CENTRAL COAST COUNCIL
DEVELOPMENT & REGULATORY SERVICES

Application No: DA216005

Representation/objection to DA216005
468 West Pine Rd,
West Pine.

The latest planning assessment for 468 West Pine Rd is designed to get an existing (unapproved) large water tank and existing (unapproved) laundry approved, plus a new storm water disposal area. The tank and laundry are integral to the existing B&B and church residence. Whether the Central Coast Council Planning department will be considering retrospective approval, or will be treating the application as if the structures are yet to be built, my points of objection fit both scenarios. Some of the language in the application seems to jump between the two.

Photo 5: Photo showing the laundry and Church to the right, the B&B centre and the 110,000 litre water tank to the right.

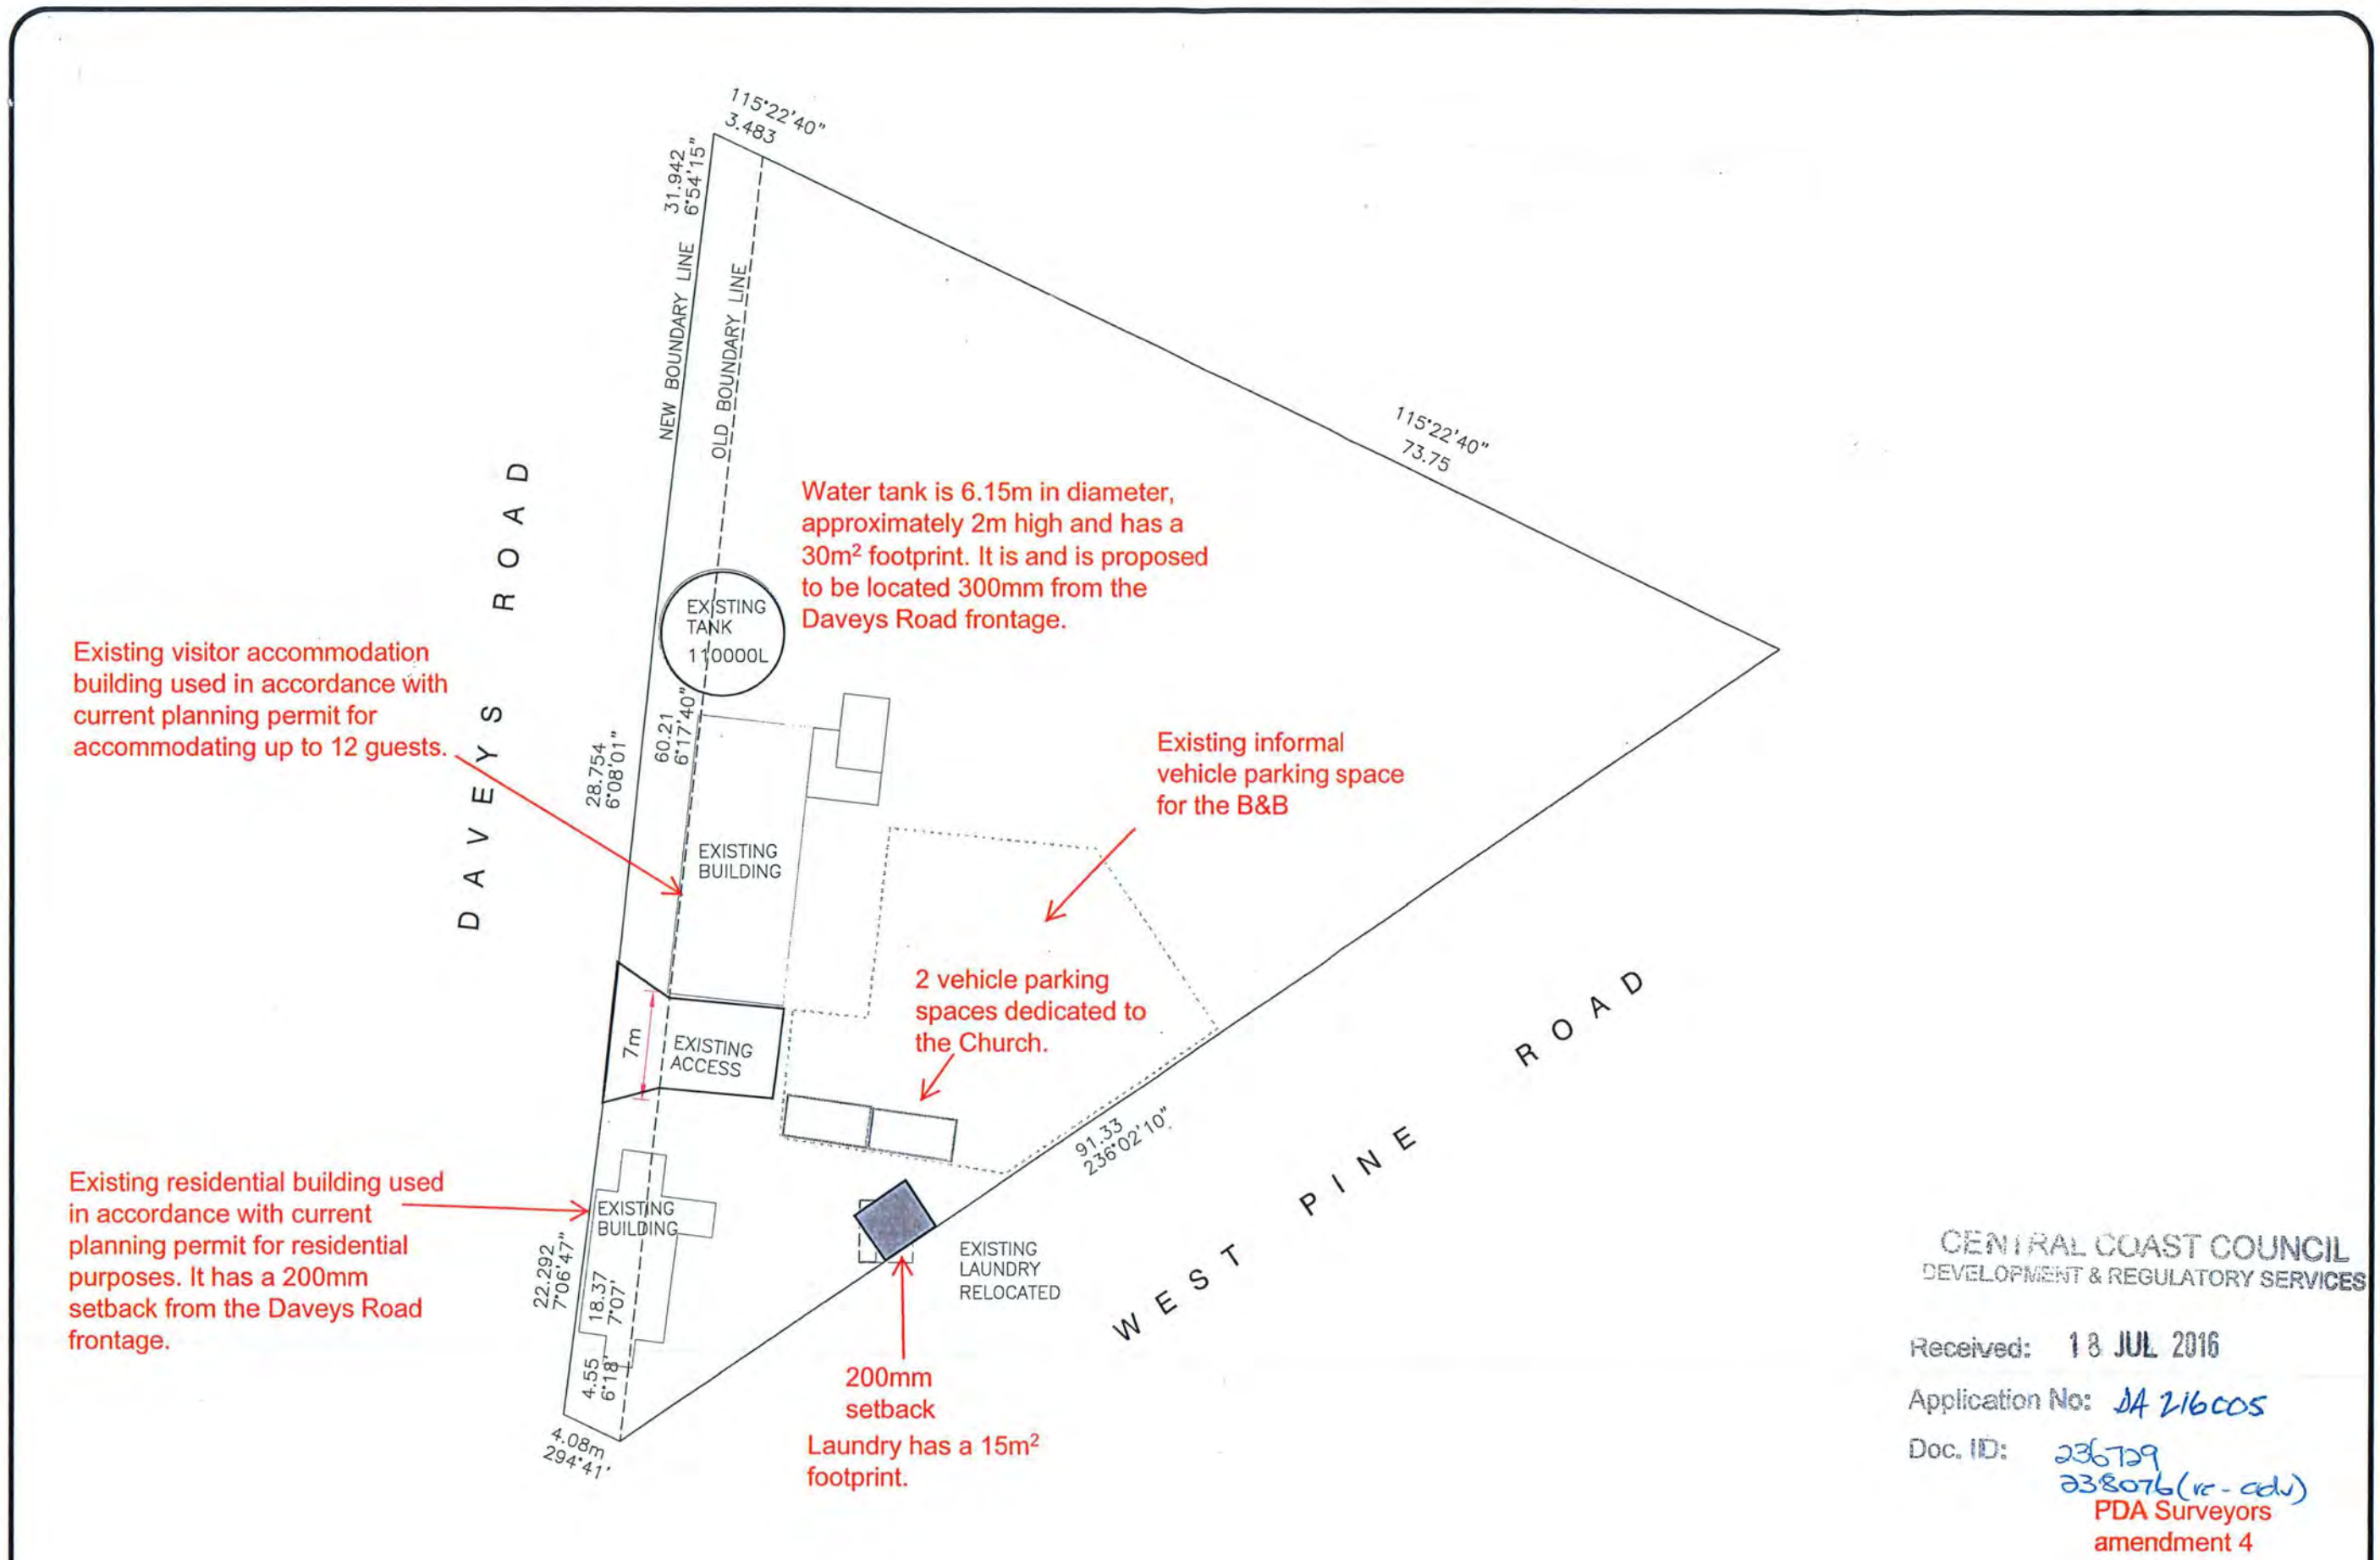
The DA has the tank staying where it is – there is no satisfactory justification for this, there is room elsewhere on the block that would satisfy setbacks, and the streetscape would be much improved. Streetscape will be commented on later in this document, as it is an important aspect of the development.

The Justice Department gives the diameter of the tank as 8m, while the figure given in the DA is 6.15m. Which is correct?

26.4.2. The planner makes a comment about the tank '.....it is considered that the setback of the tank is reasonably compatible with the existing buildings, and also compatible with setbacks in the streetscape'. That may as be, but excluding the church, the other buildings are certainly not compatible with the general streetscape setbacks of the district, and more specifically those in Daveys and West Pine roads.

Comment: The water tank and laundry are not significant features in context of the existing and approved buildings. It is noted that the water tank is lower than the adjacent buildings and has the same external materials and finish. It is considered that both the laundry and the water tank are suitably compatible with existing approved development in terms of appearance, setback and character.

Site Plan

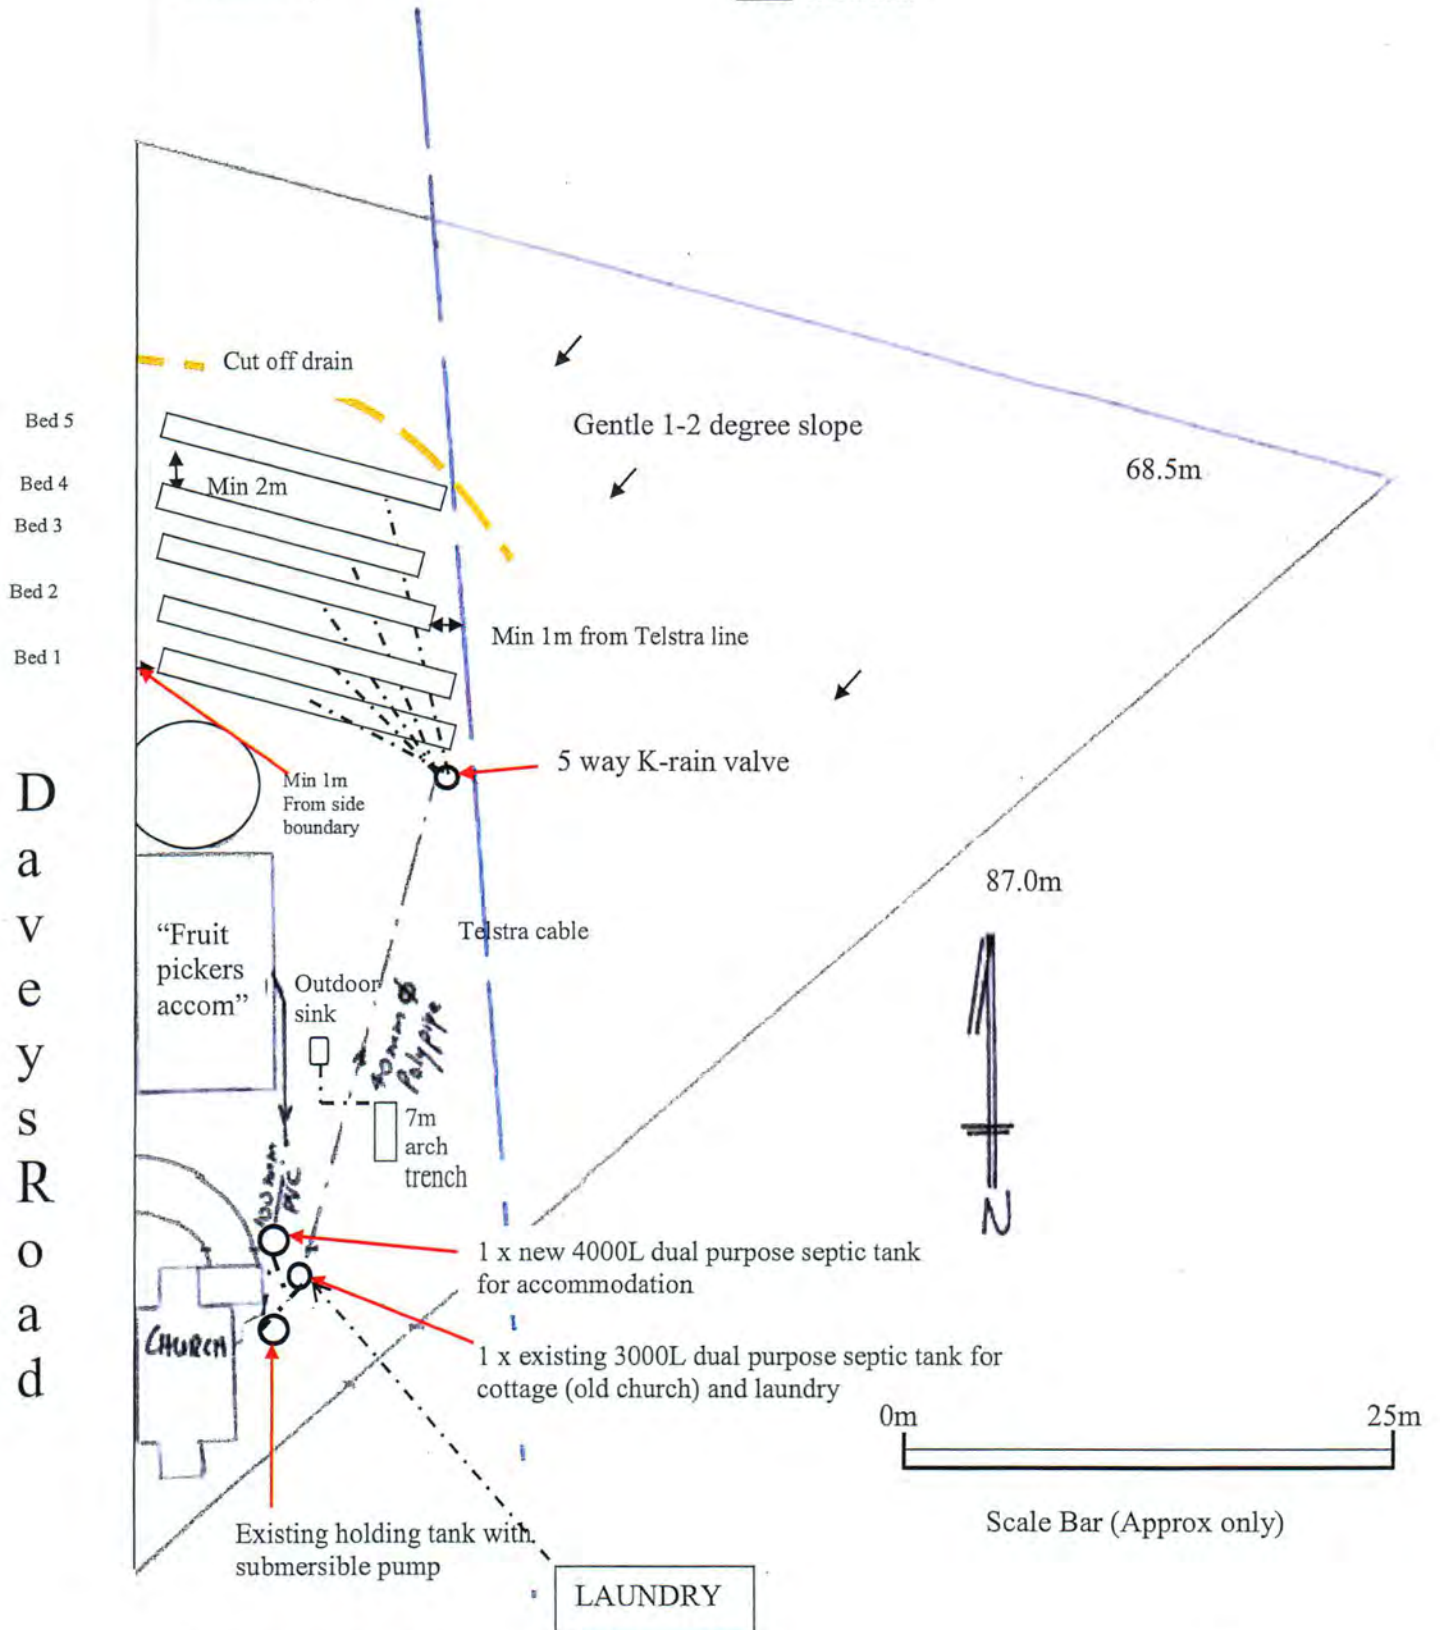
The DA proposes to put a tank/stormwater overflow trench between the road and the B&B shed. The drainage is not very good in the area shown on the plans, and is close to both the shed and the road. The distance of the trench from the road is only 1.5m. In one of the previous withdrawn applications there is the possibility of a fire escape being put between the shed and the proposed trench – if so, the small area in question would be getting pretty crowded. Of interest is the figure of 600m being given for the depth of the trench – presumably 600mm is the correct figure. Two standard rulers deep. Given the

roof area of the shed, laundry and church, I wonder if this trench, in its current proposed location, would be sufficient for successful soakage without leakage on to the road, in the event of a wet winter and a full tank. The stormwater/tank overflow needs to be fully contained on the property.
